FINAL TECHNICAL MEMORANDUM

TO: Dan Heilig, Wyoming Outdoor Council and
Jill Morrison, Powder River Basin Resource Council
FROM: Jean Marie Boyer, PhD, PE, Hydros Consulting Inc.
SUBJECT: Review of ERM Water-Quality Modeling Study of Boysen Reservoir
DATE: July 1, 2018

Figure 2. Wind Speed Figure from the ERM Report. Red line added at 5 m/s (9.7 knots)

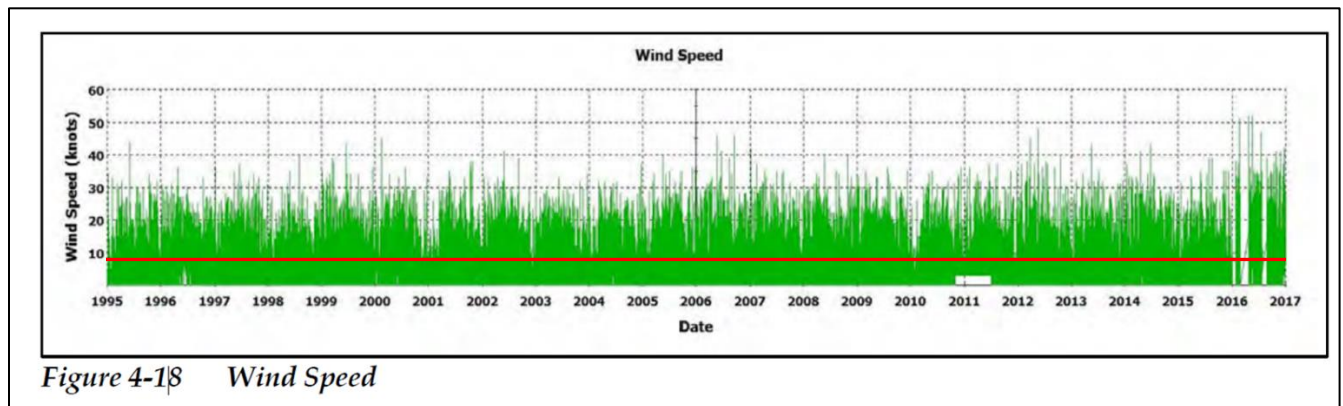
5. Wind Speeds Were Significantly and Unrealistically Capped

The Wind River basin experiences high wind conditions, as displayed in Figure 2 where wind speed is reported in knots. The model as delivered to Hydros by ERM is set up to “cap” wind speeds to a maximum of 5 m/s (9.7 knots) during the simulation, as indicated by the model setting in Figure 1 above.

Artificially reducing the wind speed serves to reduce mixing and increase stratification (something the model has troubles simulating). It appears that the modeler used this cap to make up for other important model development problems. This significant adjustment was not described anywhere in the Report and the reader is led to believe that the values shown in Figure 2 were used.

Figure 3. Assumed Iron Concentrations at the Wind River Above Boysen Reservoir (from Report)

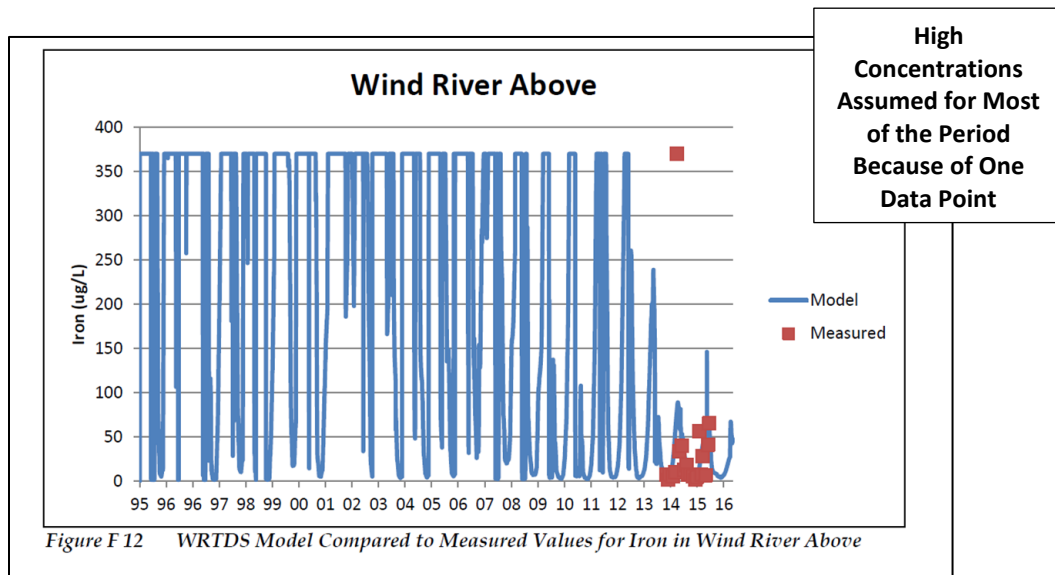
7. Questionable Use of Method for Quantifying Inflow Concentrations

For some constituents, ERM used the WRTDS (Weighted Regressions on Time, Discharge, and Season) method to describe inflow concentrations for Wind River above the reservoir, 5-Mile Creek, and Muddy Creek (see Appendix F of the Report). The results from using this methodology are questionable and unrealistic in some cases. ERM subjectively capped what was determined to be excessively high concentrations. In addition, odd results sometimes occurred due to extreme values in a single or few data points and certain trends were created that are not described or justified. Examples are shown in Figures 3 and 4. Note that Wind River provides the majority of the inflow into the reservoir (over 70% according to Appendix C of the Report) and its water quality is an important driver of in-reservoir dynamics.

Figure 7: Temperature Calibration Figure for Outflow (from Report)

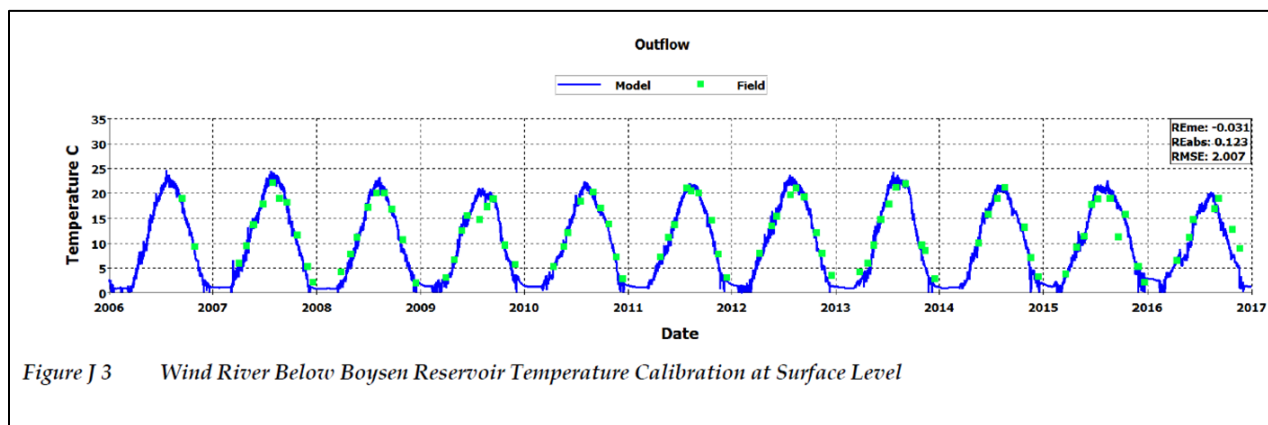
12. Evaluation and Reporting of Wind River Results are Wrong and Misleading

Through review of the model files, our team determined that the graphs displaying calibration and validation results for the Wind River below the reservoir are misleading and severely flawed. An example graph for temperature is shown in Figure 7. The top of the graph is labeled as “Outflow” and the caption says “Wind River Below Boysen Reservoir.” The data (green markers) are reportedly Aethon’s temperature measurements in the Wind River below the dam. The reader is led to believe that the blue line represents the temperature of the water released from the reservoir (via the low-level outlet and/or the spillway) and delivered to the river.

According to the model files, the blue line actually represents the simulated temperature at the top model layer (~top 2 feet) of the most downstream location (at the dam). This is wrong and misleading and it is unclear why this was done. Note that ERM added “at Surface Level” at the end of the caption (Figure 7) and perhaps thinking this makes it not misleading, even though there is a low-level outlet used for power production?

This is a very serious problem since the water quality at the top two feet of the reservoir is being represented as Wind River water quality and there are observed (but not simulated) vertical variations in the reservoir. In reality, the water quality at the top of the reservoir is often different from the bottom of the reservoir⁵ (see Figure 6). Since water is removed predominantly through the low-level

Figure 11. ERM’s Figure Showing Observed and Simulated Temperature Profiles

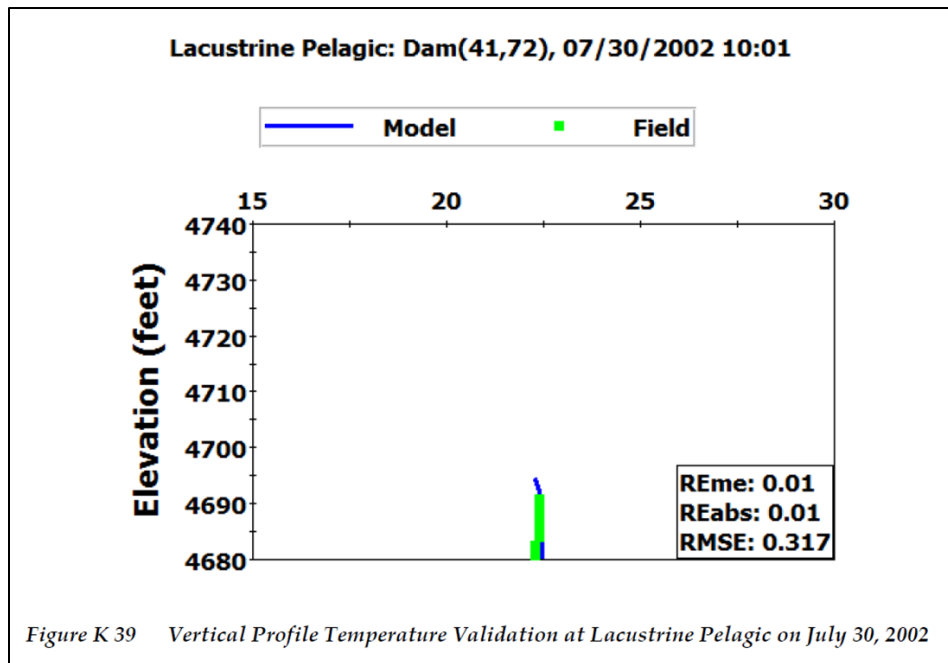
15. Information Was Concealed by Limiting Bottom Elevations Displayed on Profile Graphs

In-reservoir observed and simulated results are shown in the Report in Appendices J and K for temperature, TDS, and pH with depth. All of the graphs provide data and results for elevations above 4,680 feet. This elevation is not at the bottom of the reservoir (at least near the dam) and cutting off the elevations in the figures leads the reader to assume that the reservoir is typically well-mixed summer and does not stratify or have much vertical variation. In addition, the model results show something similar. An example is shown in ERM’s Figure K 39 (Figure 11) for July 30, 2002 near the dam, where the reservoir appears to be well-mixed with good model predictions (and hot from top to bottom).

Figure 12. Full Profile at the Calibration Site Closest to the Dam

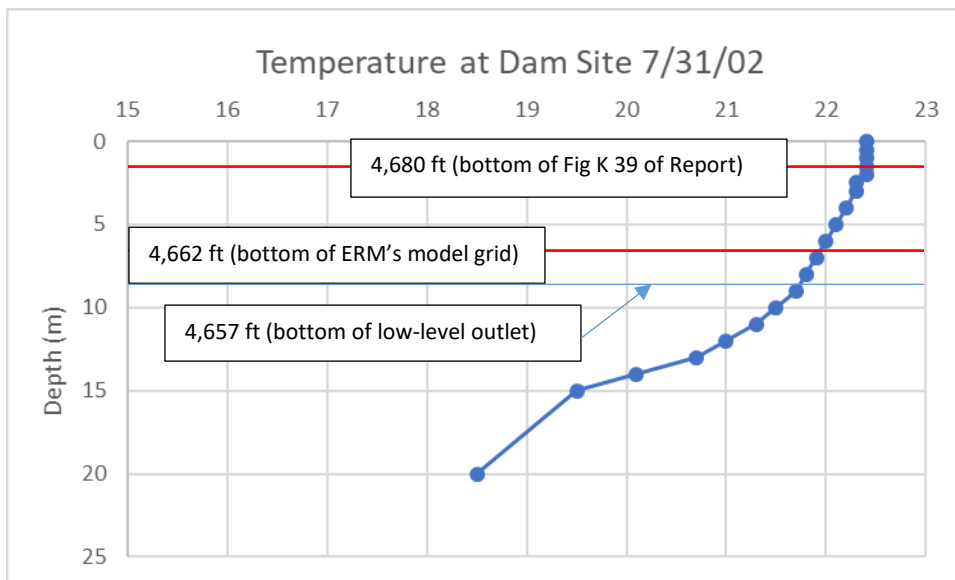
However, the full profile of observed data indicates stratified conditions (Figure 12). In addition, Figure 12 shows that ERM failed to display about 90% of the observed profile. The bottom of ERM’s model grid

at the calibration location is also indicated, showing that the model grid is not deep enough near the dam. Nor is it deep enough to reach the lower-level outlet. This also highlights significant issues with the development of the model grid (which isn't deep enough to reach the lower-level outlet).

Figure 13. Example Temperature Profiles Displaying All Observations and Model Results from Top to Bottom of the Reservoir. Data from Lacustrine Pelagic: Dam Site

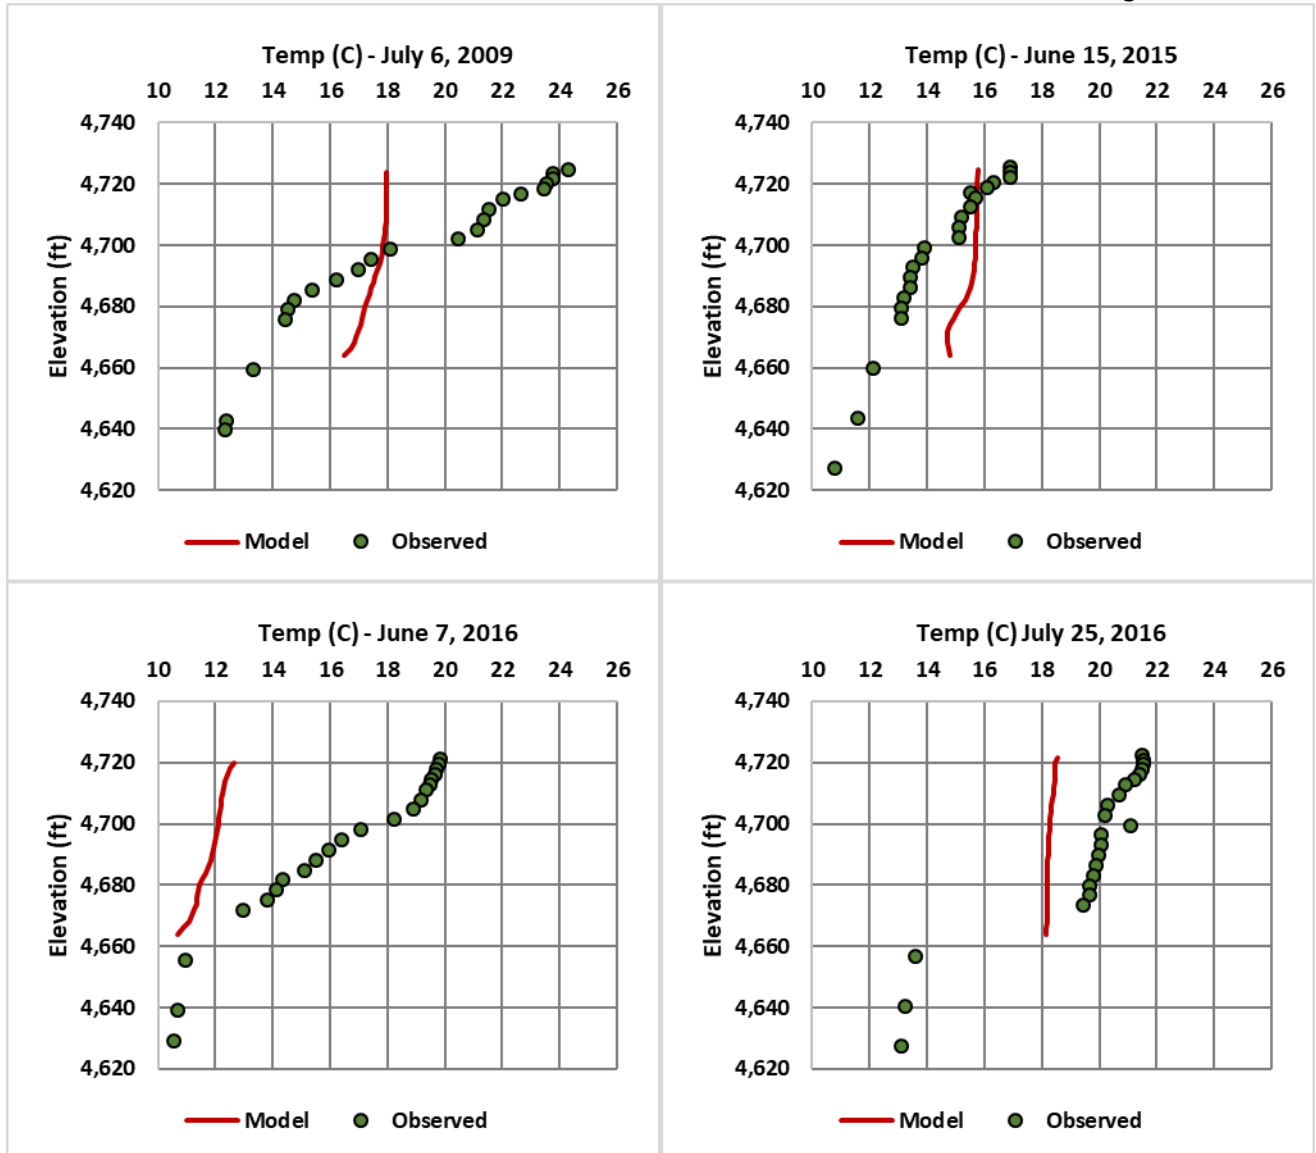
17. Simulation Results are Poor

Even though a number of adjustments were made during model development and calibration, the model results are very poor. Temperature profiles near the dam (Figure 13) show that the model is not capturing observed stratification in the summer and shows very little variation top to bottom. Reservoir temperature calibration is an initial and very important step in modeling. Recall that water in Boysen Reservoir is released to the Wind River via a low-level outlet (elevation 4,657 ft) and an upper spillway, at times. This makes it even more critical to be able to capture the vertical variations. As described earlier, using commonly-accepted calibration targets, the ERM model is not adequate for use. Also note that the bottom of the model grid at this calibration location is so high that water in the bottom 35 feet of the reservoir is ignored. Thus, water quality in this region (near the lower level OLW) is not even simulated.

Figure 14. Example Specific Conductivity Profiles Displaying All Observations and Model Results from Top to Bottom. Data from Lacustrine Pelagic: Dam Site

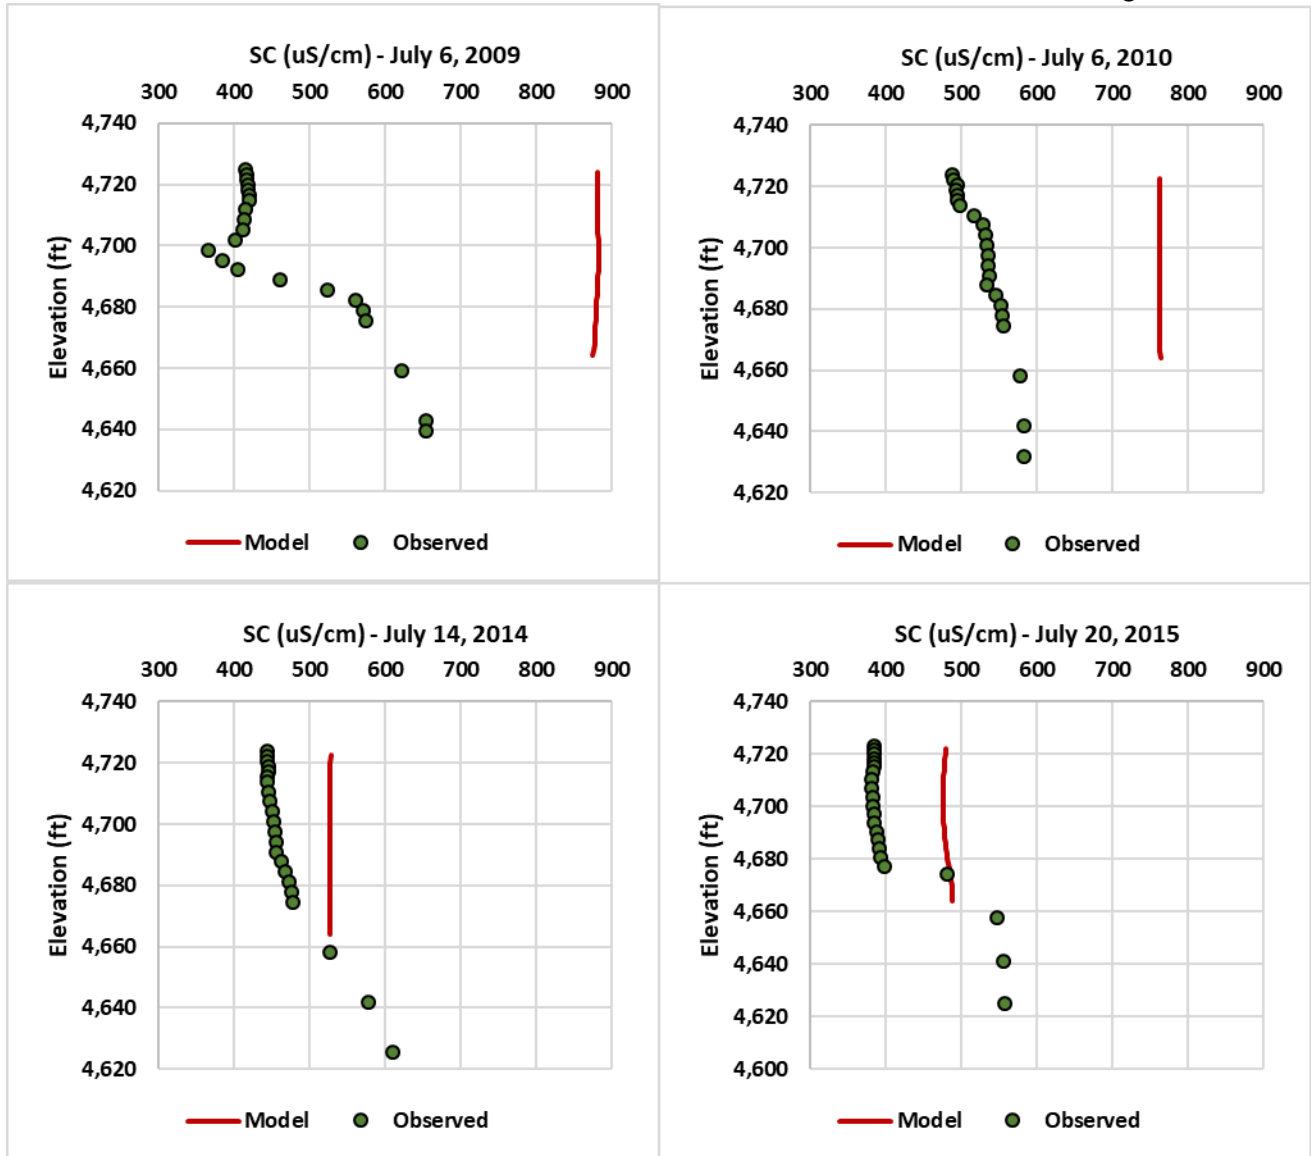
Specific conductivity profiles are shown in Figure 14. Again, the vertical variations are not captured and sometimes the magnitudes are overestimated by 100's of uS/cm. Note that most of these are in mid-summer, when the % produced water increases (see Figure 10).

Figure 17. Model Output for “Outflow” (Top 2 ft of the Reservoir); Model Calibration and Case 01

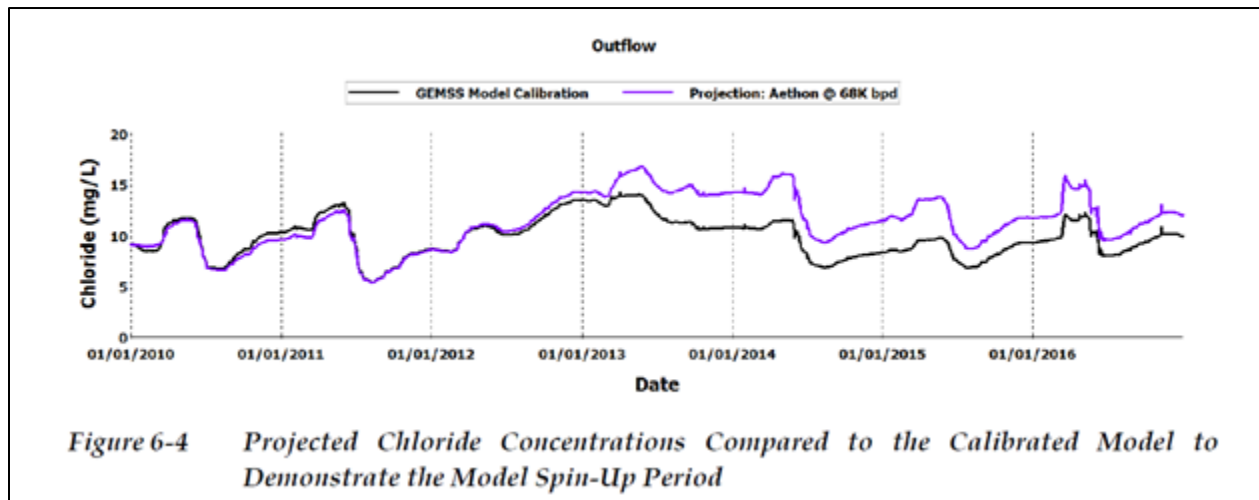
ERM did display chloride results in an attempt to justify the model “spin-up” period and to only focus on model results from December 2010 – March 2016 (Figure 17). Note that the project results in lower chloride concentrations in the “outflow” (top 2 feet of the reservoir) in 2010-2011.

Because the projection flows (68,000 bpd; Case 01) are lower than what actually occurred in 2010 and 2011, the model shows an improvement (lower concentrations) with the project. Starting in 2013, when the projection flows are much higher than the actual, the model shows some significant increases in concentrations (Figure 17).

Figure 19. ERM Figure Showing Impact of the Project for Case 01

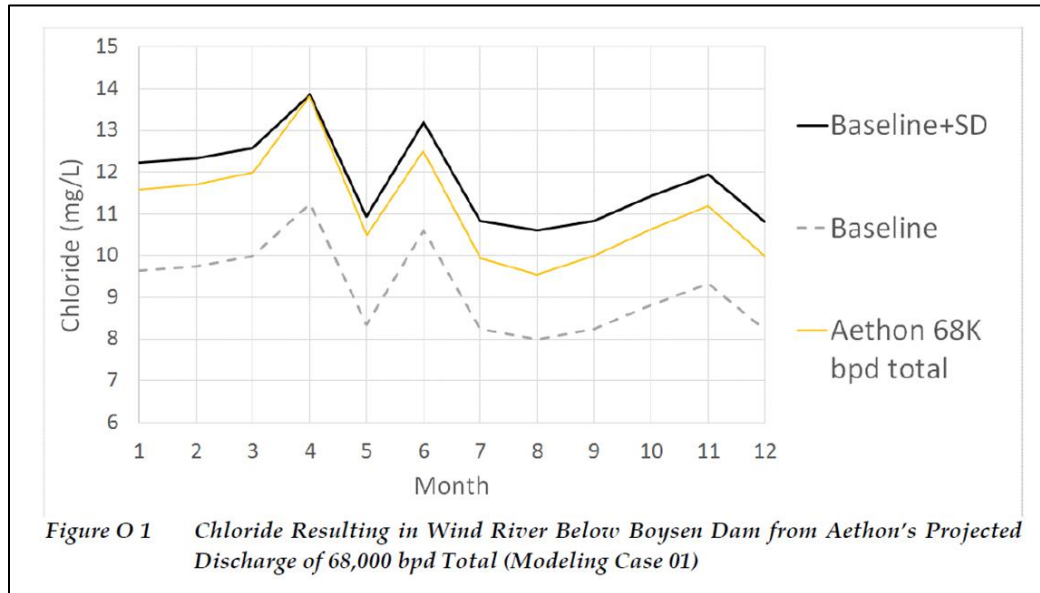
The analysis should be presented on a daily basis so that periods of larger impact are transparent. For example, from Figure O 1 (Figure 19), the reader could assume that April concentrations may only increase by up to 2.7 mg/L chloride, while the time-series data (Figure 17) show increases of up to 4.6 mg/L at times.

Figure 21. ERM Results for the Compliance Analysis for Dissolved Nickel (Red Line and Two Text Boxes Added)

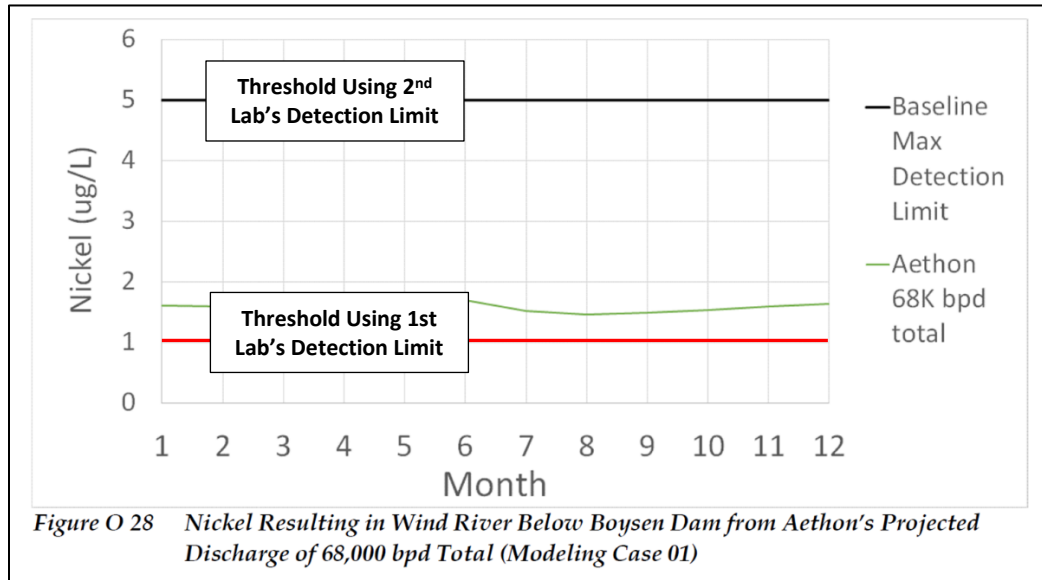
Using the approach developed by ERM, the results are displayed as Figure O 28 in Appendix O (see Figure 21). Using the threshold of 5 ug/L (based on the 2nd lab's detection limit), it appears that the project will not result in degradation in the Class I section. However, if the lab change had not occurred (or if the minimum DL was chosen), then the conclusion would be that degradation would occur.

Overall, this method and its implementation are flawed.

Figure 23. ERM Results for the Compliance Analysis for Dissolved Aluminum (Red Line and Two Text Boxes Added)

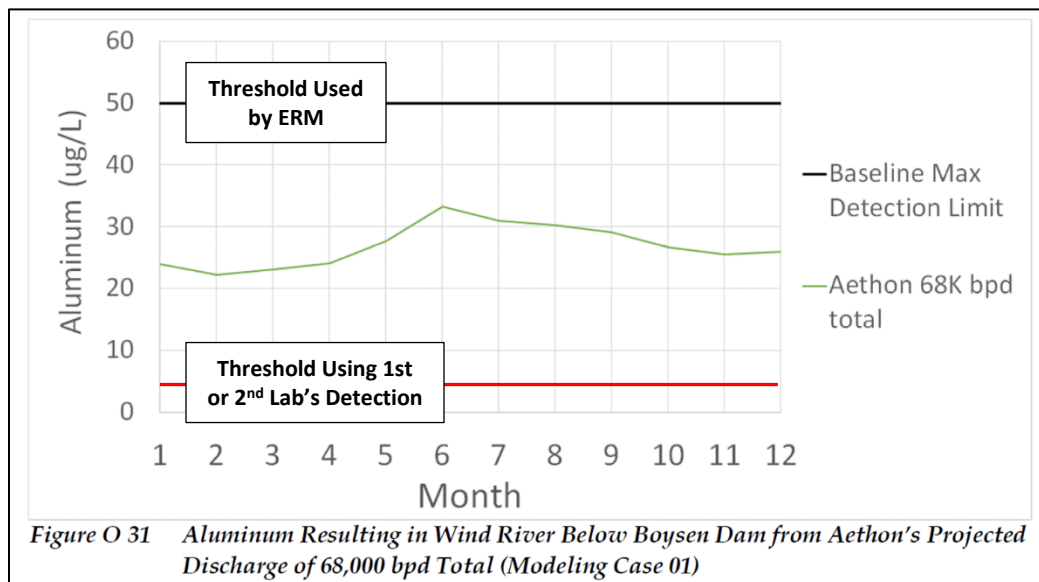
After lumping the model results and applying the adjustment factor (described above), the monthly model results are in the range of ~22-33 ug/L (Figure 23). This would show a problem if one compares these values to the 3-4 ug/L detection limits. ERM chose to set an alternative threshold of 50 ug/L and using that threshold, the project would not result in degradation.

The source of the 50 ug/L threshold appears to be the required detection limit for dissolved aluminum at the end of the pipe (WDEQ, 2019a). This 50 ug/L detection limit does not apply to the Class I segment of the Wind River (since it is not effluent) and use of this value by ERM for compliance is wrong.
